**CITY OF AUSTIN  
APPLICATION TO BOARD OF ADJUSTMENT  
GENERAL VARIANCE/PARKING VARIANCE**

STREET ADDRESS: 4406 Rivercrest

**Re:** 4406 Rivercrest Drive AP-2014-0119DS Update #1

## 4406 Rivercrest Drive

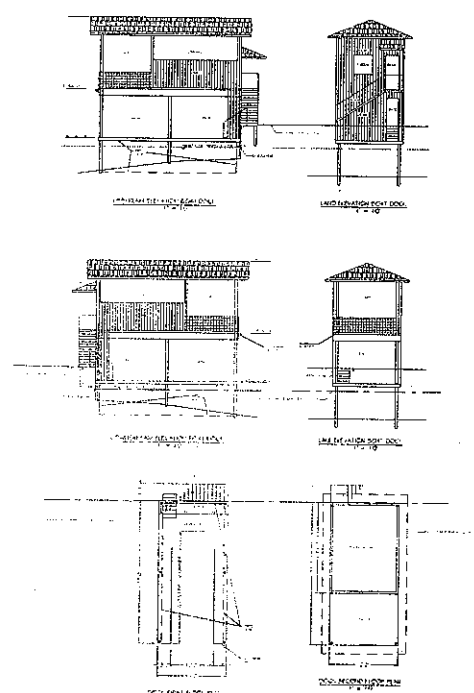
project. Make sure that it is at least 4" x 4", of sufficient scale and quality to be legible, and that it identifies effectively where the proposed work is to take place. Add a north arrow, call out "Lake Austin" and clearly delineate the shoreline.

SP 13. Add note on the site plan indicating piling size.

- EV 5 The location of the existing bulkhead is unclear from the drawings submitted. Please provide an existing conditions plan separate from the proposed plan. The zig-zag line is called out as the bulkhead/shoreline, but there is another bold line in front of that line, which is unlabeled. Please clarify what that bold line indicates.

- EV 6 Comment is pending approval by Planning Commission for exceeding the 20% width allowance and extending greater than 30' into Lake Austin.

- SP 1. Provide this reviewer with a full-sized and legible copy of the subdivision plat. On the plans, show all boundary lines with bearings and dimensions in accordance with the recorded subdivision on all sheets. Also, provide copies of all restrictive covenants and/or HOA agreements pertaining to this property.

- SP 2. Depict and label the lake gradient line on the site plan, showing the shoreline during the period when the lake is lowered. The Lake Austin gradient line normally follows the 482.0 ft. contour, and the proposed boat dock cannot extend past the gradient line. Please provide the topographical datum basis used for location of the gradient line.

- SP 3. Call out the Lake Austin shoreline elevation as 492.8.
- SP 4. Will all the work be performed using a barge, or will materials and equipment be stored on land, or will workers also access the site via land? If so, the limits of construction should be adjusted accordingly on the site plan. If all work will be accomplished with the barge, then place the following note to the cover sheet: "All work on this project is to be accomplished via barge. There will be no site access by land, nor will any construction staging or materials storage be located on land." Please be more specific in the description on the cover sheet.

- SP 9. It appears that the proposed boat dock extends approximately 33 feet from the shoreline, exceeding the allowed maximum of 30 feet [Section 25-2-1176(B)(2)]. Either reduce this extension into the lake, or request approval from Planning Commission.

- SP 10. Demonstrate that the proposed width of the boat dock does not exceed twenty percent (20%) of the length of the shoreline. The boat dock appears to measure more than 50% of the property width/length of shoreline.

- SP 11. Please provide all four sides of the boat dock elevations, to help verify compliance with openness.
- SP 12. Please provide a clear site location map with adequate detail – the map on the cover sheet does not provide sufficient information in regard to the actual location of the

SP2,3,6&11 The requested changes have been made on the plans.

SP4 No, we don't anticipate all work to be done via barge since there is a PAVED common access easement adjacent to the docks for all the dock in the area. We expect workmen and there tools will arrive via land.

SP 9-10 We understand that PC consideration is required for approval of the width and depth.

EV6 We understand that PC consideration is required for approval of the width and depth.
